## **ADDENDUM 4**

<u>SUBJECT</u>: Sidney Brooks (City Base Land – S New Braunfels) 2022 Bond, (ID No.: 23-03916)

# THIS NOTICE SHALL SERVE AS ADDENDUM NO. IV - TO THE ABOVE REFERENCED INVITATION FOR BIDS

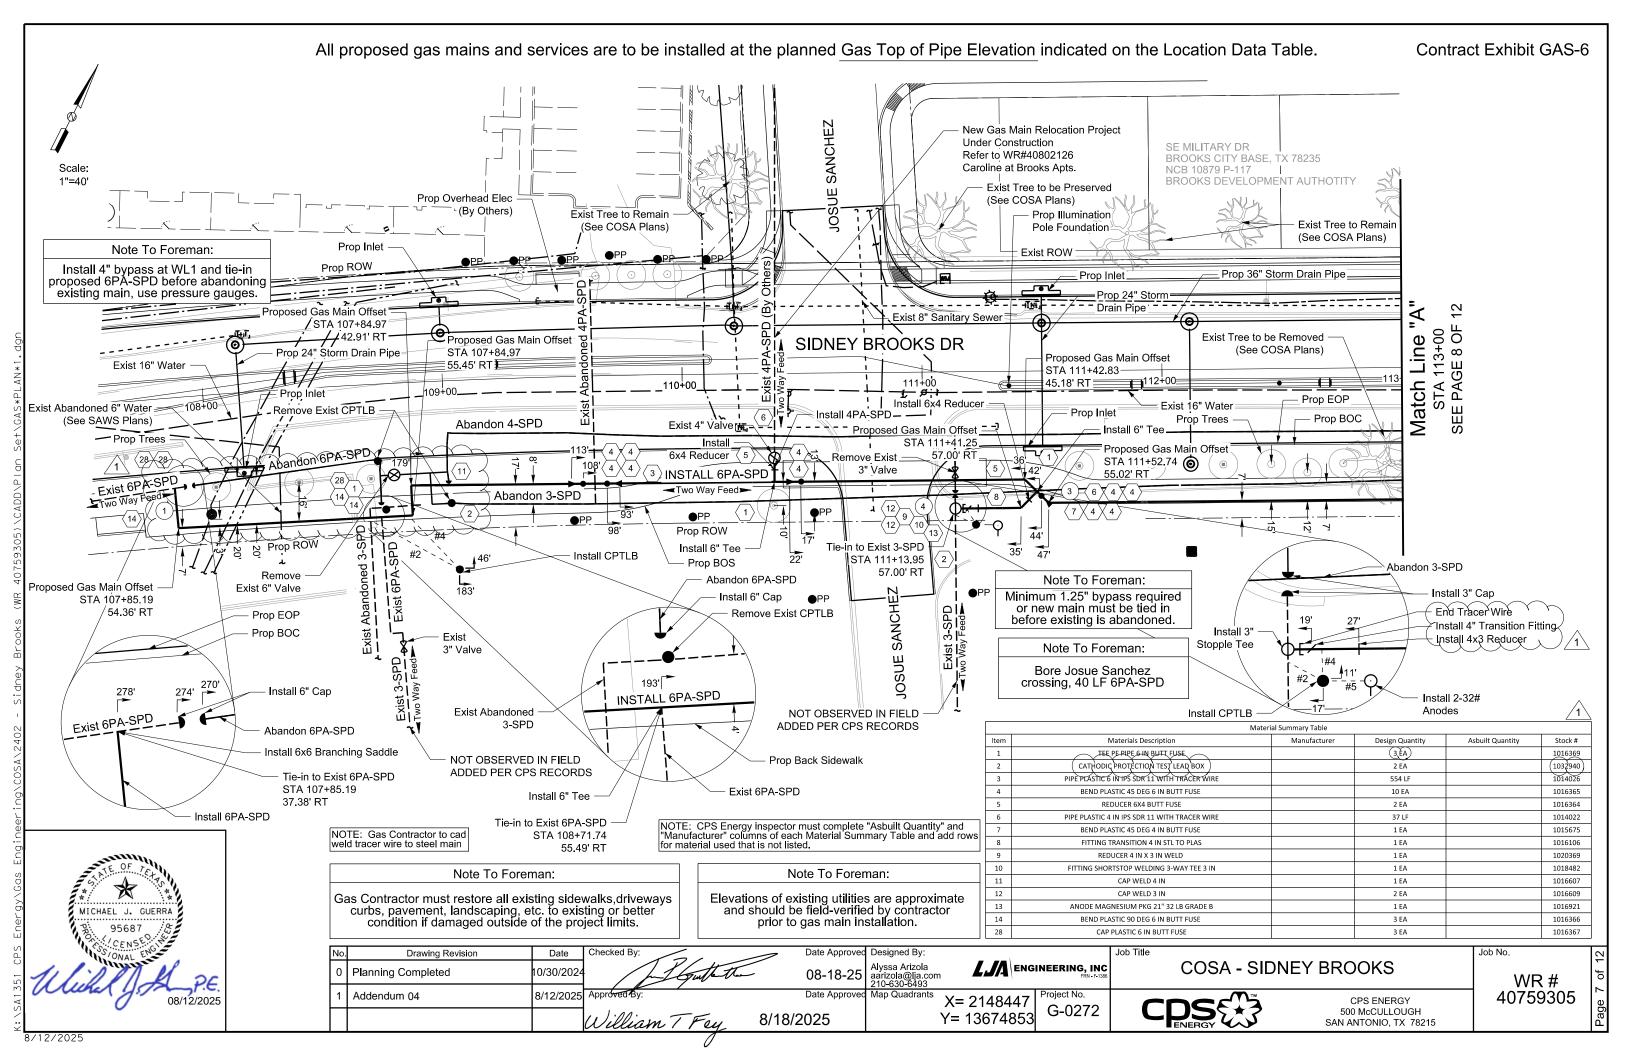
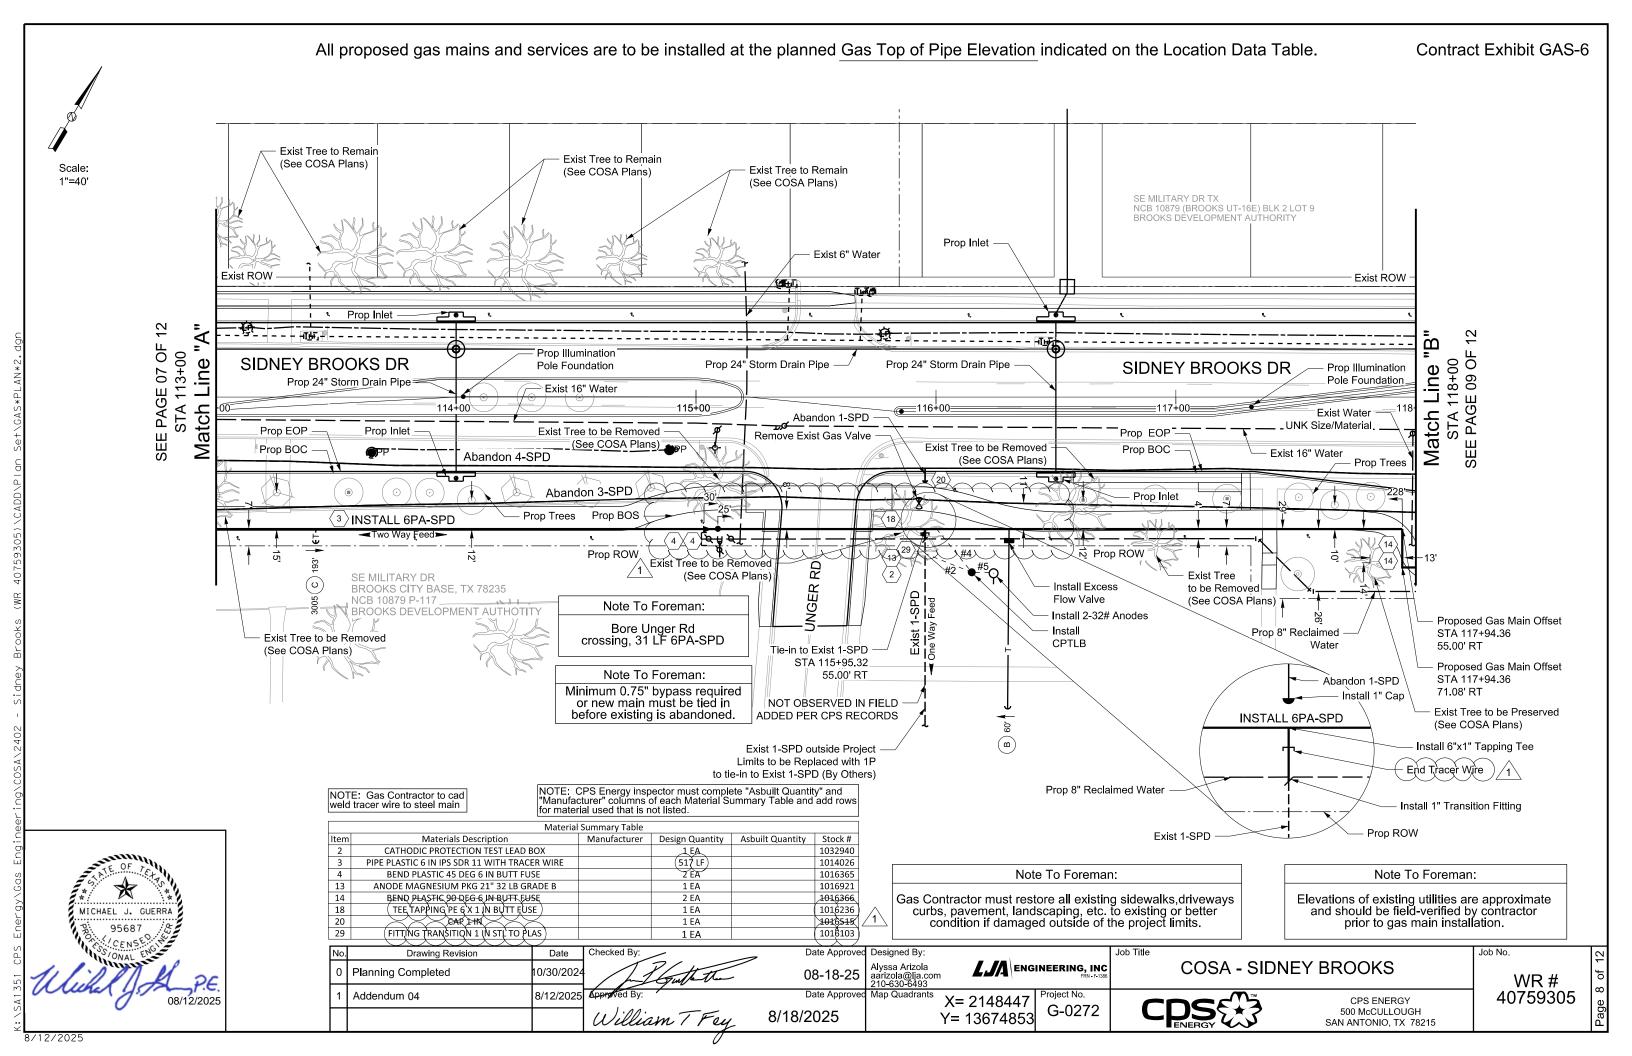
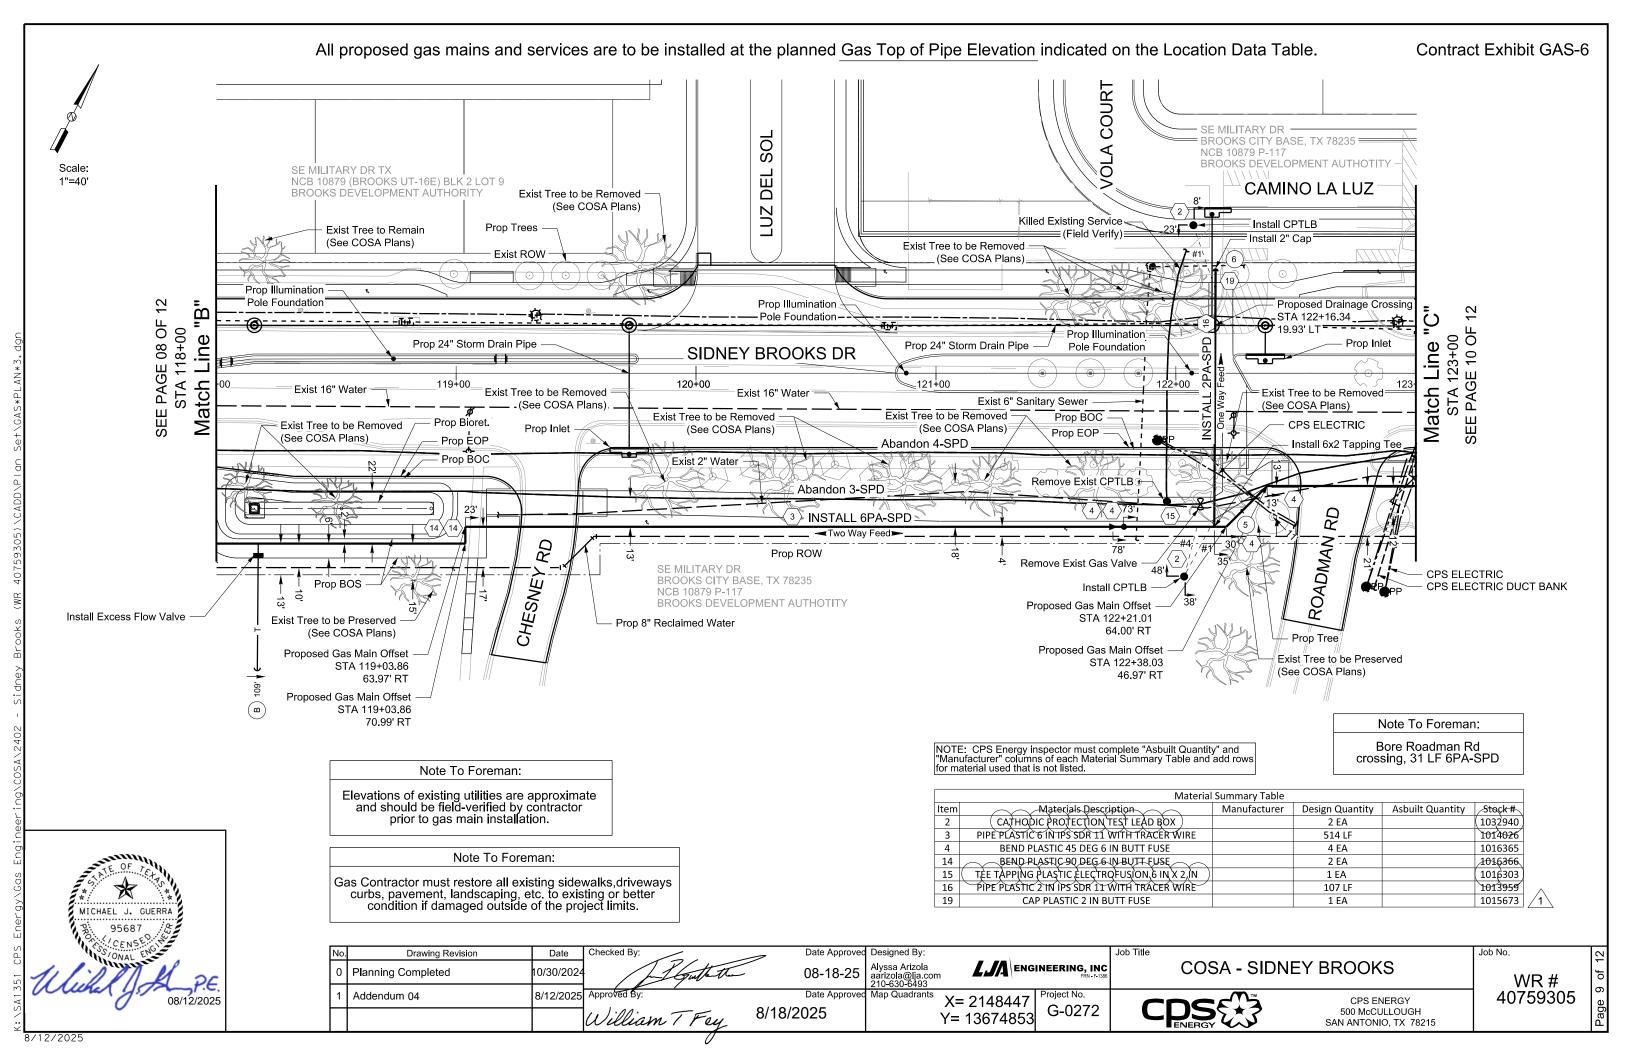
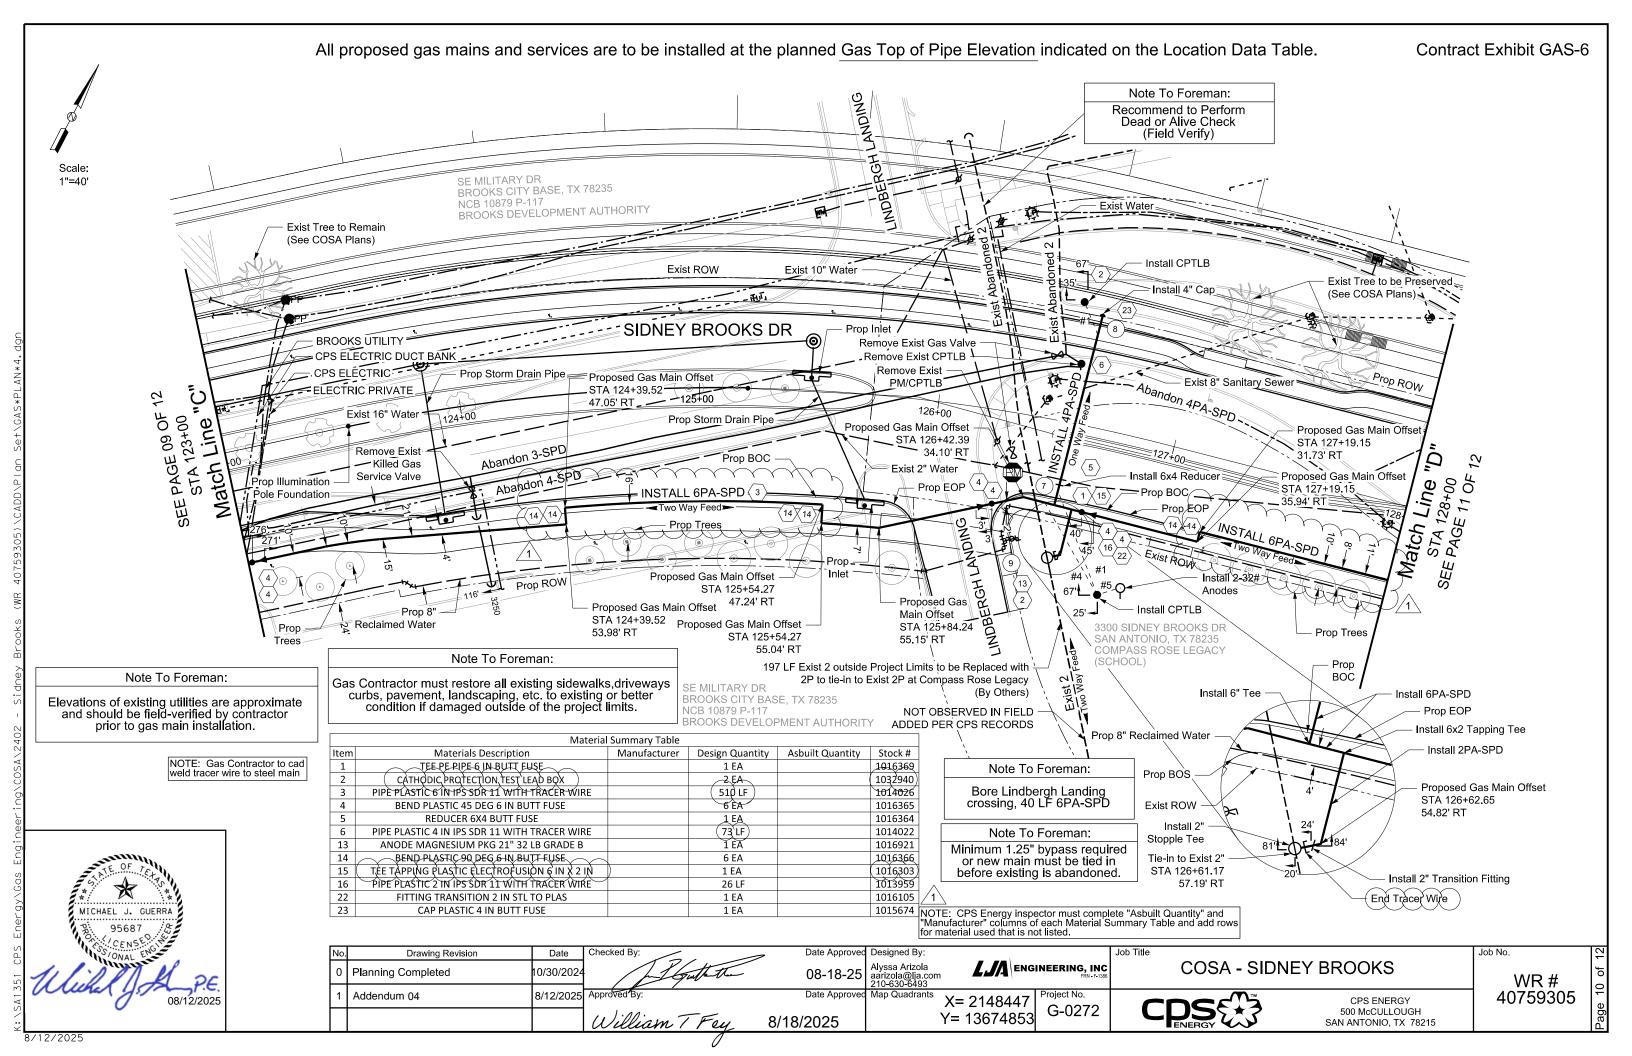
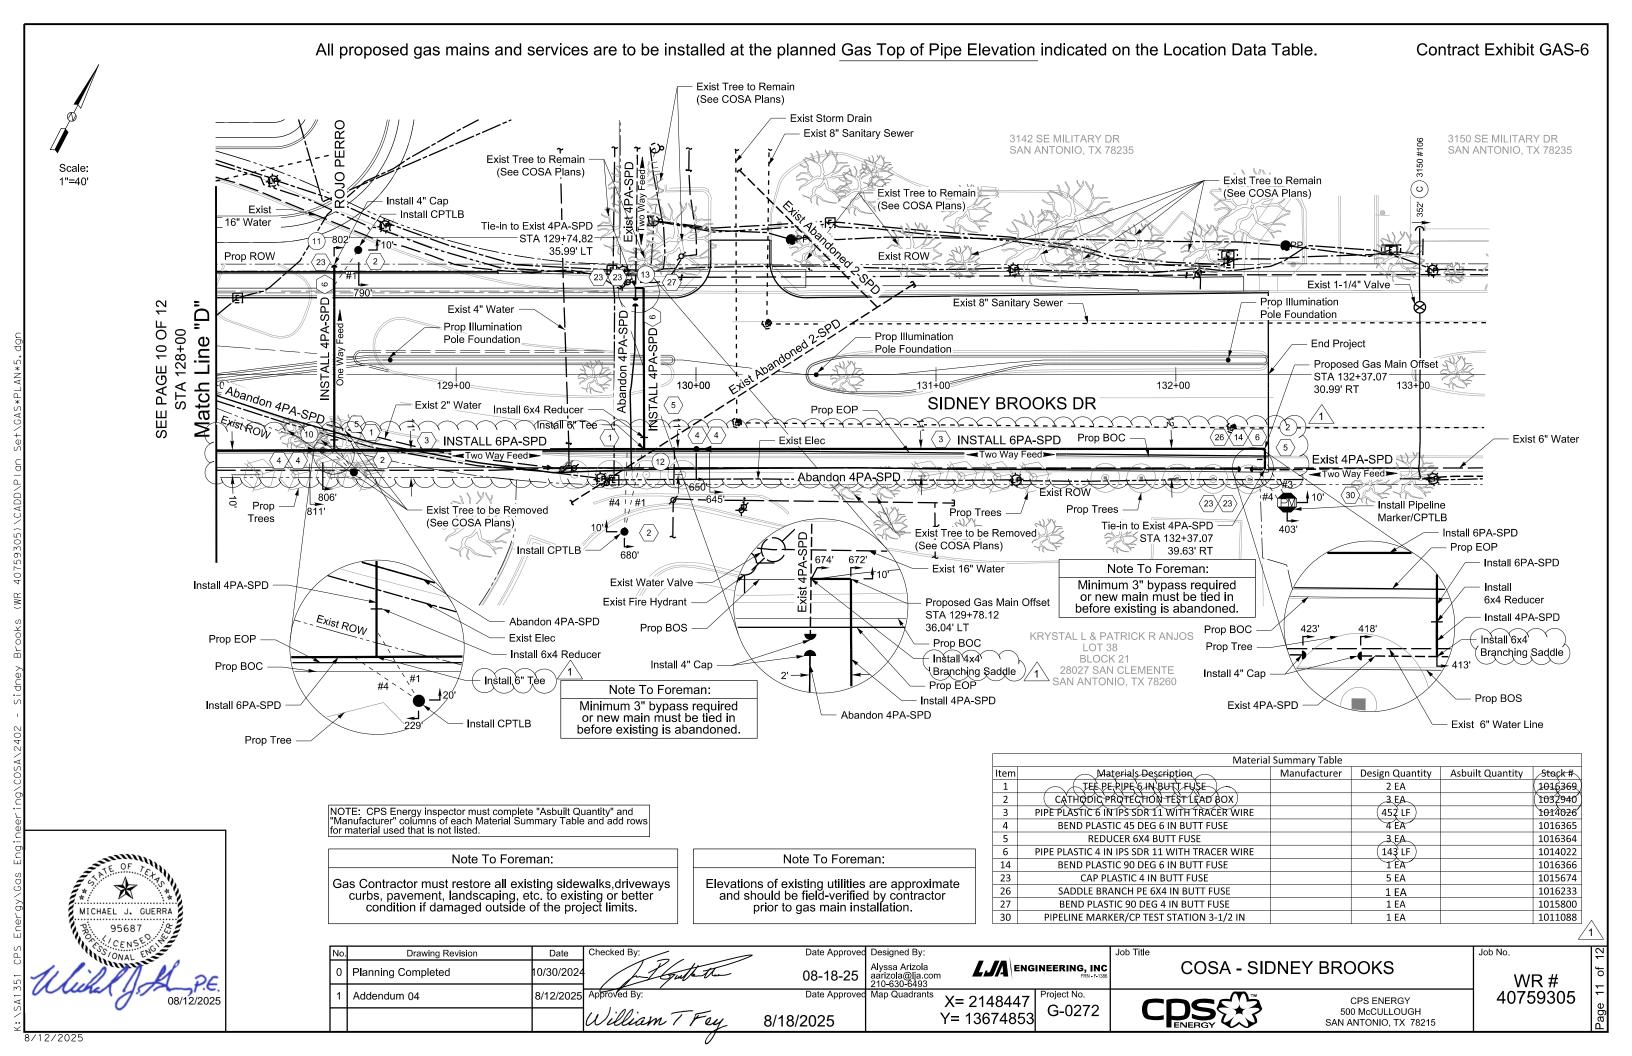
- 11. Sheet 333 CPS Gas Plans Summary Sheet 6:
  - a. Removed various segment runs and revised quantities to reflect updated quantities.
- 12. Sheet 334 CPS Gas Plans Sheet 7:

- a. Revised plan sheet. Tie-in location was shifted further west to provide clearance for proposed inlet.
  - b. Revised Quantities to reflect revised design.

- 13. Sheet 335 CPS Gas Plans Sheet 8:
  - a. Revised plan sheet. Adjusted tie-in to account for planned tree removal.
  - b. Revised Quantities to reflect revised design.

- 14. Sheet 336 CPS Gas Plans Sheet 9:
  - a. Revised plan sheet. Gas Alignment was shifted further north to provide additional clearance to proposed trees.

- b. Revised Quantities to reflect revised design.
- 15. Sheet 337 CPS Gas Plans Sheet 10:
  - a. Revised plan sheet. Gas Alignment was shifted further north to provide additional clearance to proposed trees.

- b. Revised Quantities to reflect revised design.
- 16. Sheet 338 CPS Gas Plans Sheet 11:
  - a. Revised plan sheet. Gas Alignment was shifted further north to provide additional clearance to proposed trees.

- b. Revised Quantities to reflect revised design.
- 17. Sheet 339 CPS Gas Plans Sheet 12:
  - a. Omitted Barlow Equation for Plastic Pipe.
